METROPOLITAN AREA PLANNING DEPARTMENT

July 31, 1998

Re: Administrative Adjustment 98-13: Administrative Adjustment to reduce the compatibility setback from 25 feet to 24 feet on the north side of the property.

Legal Description: Lot 14, 15, 16 and 17 Shreck's Addition.

Site Plan
1" = 20'-0"

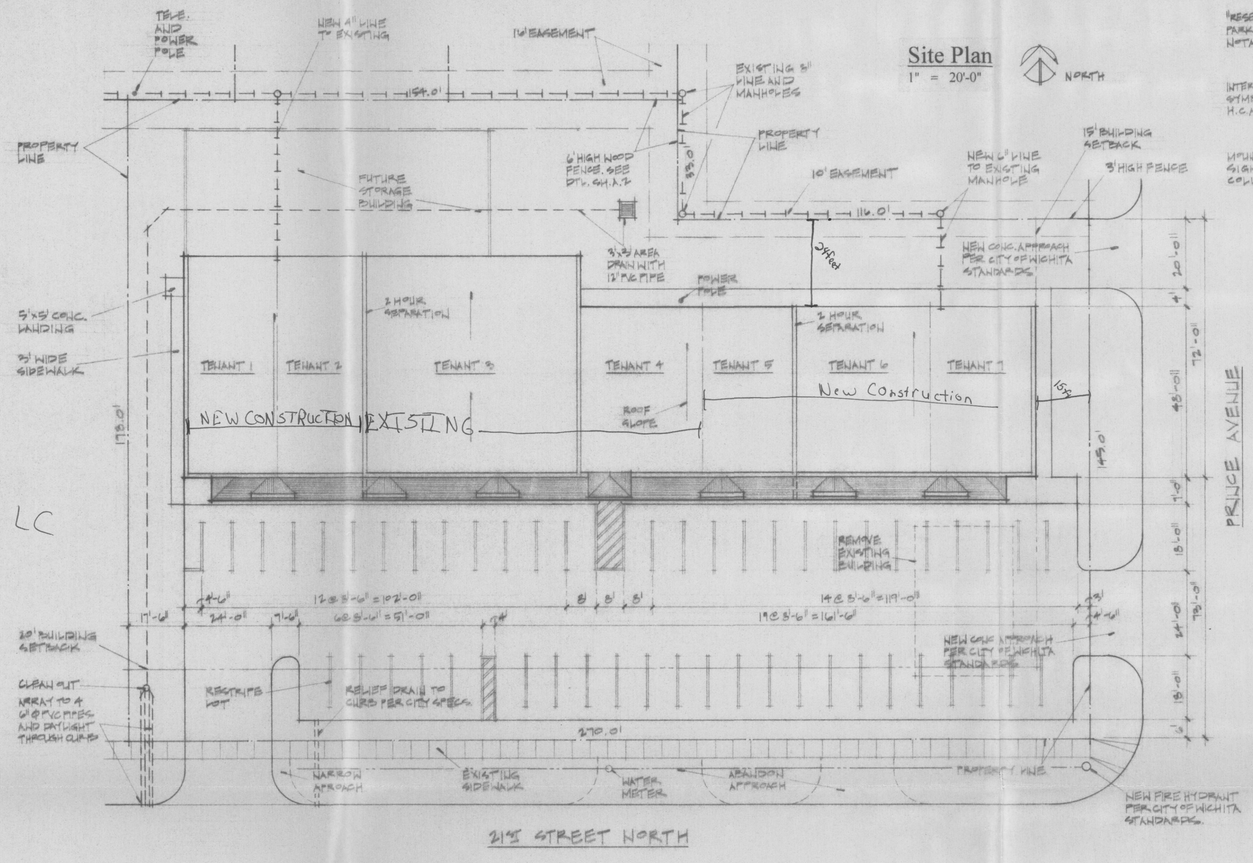
We have reviewed your request of an administrative adjustment to reduce the compatibility setback from 25 feet to 24 feet on the north side of the property. You have stated you would like to expand your existing building to the east and west. Due to your property being zoned "LC" Limited Commercial and the property to the north being zoned "SF-6" Single-Family you are required to maintain a 25 foot compatibility setback from the residentially zoned property. The compatibility setback will be met on the west side of the property but not on the east portion of this property.

As part of the this new construction you will also be required to meet the requirements of the Landscape Ordinance unless you are able to prove that you are unable to do so. The driveway along the north property line is only required to be 20 feet in width based on fire department requirements, therefore there is a four foot wide strip which could be used to meet the Landscape Ordinance requirements. The Landscape Ordinance requires eight trees to be planted along this north property line.

We find that reducing the compatibility setback from 25 feet to 24 feet (4 percent) meets the four conditions required by Section V-1.6 of the Unified Zoning Code, as set out below:

1) Impact on safety and convenience of vehicular and pedestrian circulation: The proposed expansion of the existing structure should not have a significant impact on the vehicular or pedestrian circulation in the general area. The existing access points to Prince will be brought up to City standards which should allow for better traffic flow from this site to the adjacent streets.

2) Impact on existing uses in surrounding areas: This adjustment should not significantly impact the surrounding uses. There should still be adequate separation from this lot to the residential properties to the north and the required landscaping and screening should provide

additional buffering.

3) Compatibility with existing or permitted uses on abutting sites: This site is surrounded by commercial sites on the east and west. The reduction in the compatibility setback is so minor that it seems unlikely that this site should impact the residential property to the north. If this adjustment was not granted this new structure could still be built, just one foot farther south than what is shown on the attached site plan.

4) Effect on public health, safety or welfare: There will be no encroachments into public utility easements and there should not be a negative impact on the public health, safety or welfare nor will the reduced compatibility setback be materially injurious to properties or improvements in the vicinity.

Our signatures below indicate that an administrative adjustment to reduce the compatibility setback from 25 feet to 24 feet is hereby granted subject to the following condition:

1) The applicant shall submit a revised landscape plan which meets the buffering requirement along the north property line. (A minimum of 8 trees)

2) The adjustment is only to reduce the compatibility setback from 25 feet to 24 feet for the buildings on the east portion of the property as shown on the attached site plan. This property should be developed in accordance with the site plan approved as part fo this adjustment.
